Access Compliance Report

Public Rights-of-Way

Intersection ID: N/A	Main Street: TYVOLA_RD	Cross Street: I-77	Location: NE
ADA ID: 3D0A5C3C6EAE	Ramp Type: BlendTrans1	Initial Pass/Fail: Fail	Overall Compliance: No
		Severity Score: 15

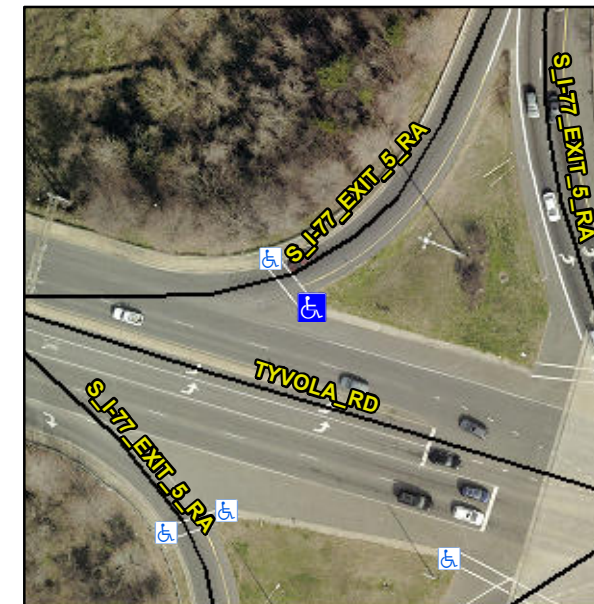
Not Found, R302.7

N/A	Ramp inside XWalk1?	Yes	N/A	Ramp inside XWalk2?	N/A
	Road Slope (%)	0.5		Clear Space?	N/A
	Road X Slope (%)	0.9	N/A	Clear Space to XWalk (in)	N/A
N/A	Any Obstructions?	N/A	N/A	Storm Grate/Utility Hazard?	N/A
	Obstruction Type			Storm Grate/Utility Type	
		N/A			N/A
			No	Surface Condition? (G/P)	Poor
			No	Curb Slope (%)	5.7

Remove & Replace Curb Ramp With Two New Directional Ramps or Equivalent.
